Technical Service Information

FORD AXODE (AX4S), AX4N (4F50N) EXPLODED VANE RINGS AND PUMP ROTORS PUMP BEARING CHANGES

Figure 2
AUTOMATIC TRANSMISSION SERVICE GROUP

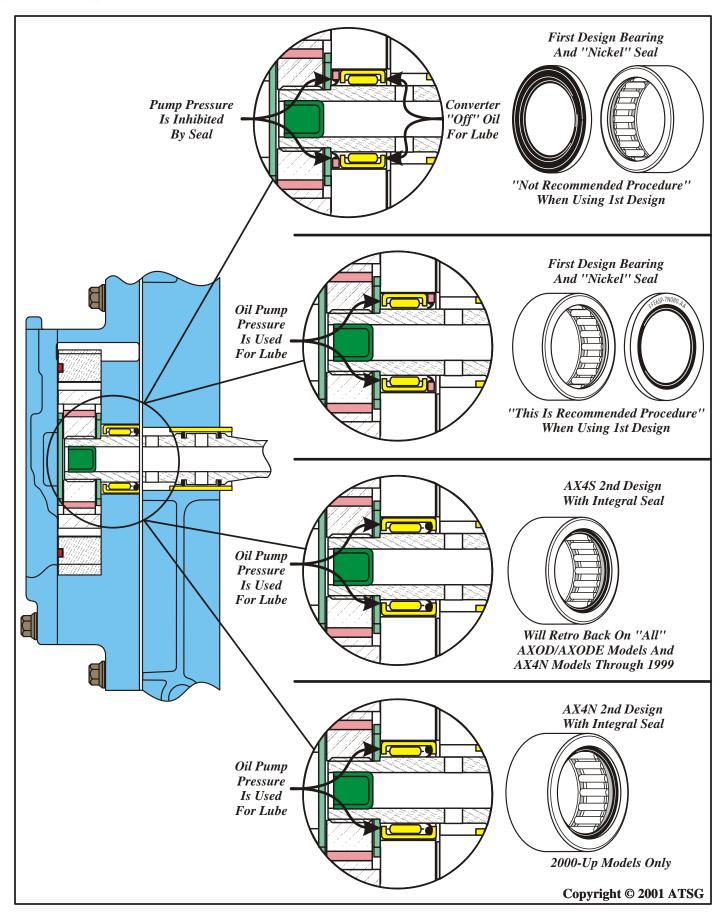
AXOD/AXODE (AX4S) - When using the 1st Design bearing with the "Nickel" Seal, install the seal on the valve body side, with the part number facing up, as shown in Figure 2.

When using the 2nd Design bearing with the integrated seal, install the bearing assembly with the integrated seal facing the valve body side, as shown in Figure 2. The 2nd Design Bearing and Seal assembly *will retro-fit back on all* AXOD, AXODE and the AX4N up through 1999.

AX4N (4F50N) - When using the 2nd Design AX4S bearing with the integrated seal on 95-99 models, install the bearing assembly with the integrated seal facing the valve body as shown in Figure 2. When using the 2nd Design AX4N bearing assembly with the integrated seal, install the bearing assembly with the integrated seal facing the valve body side, as shown in Figure 2. The 2nd Design AX4N bearing assembly will fit only 2000 models and later because of the increased diameter (See Figure 1).
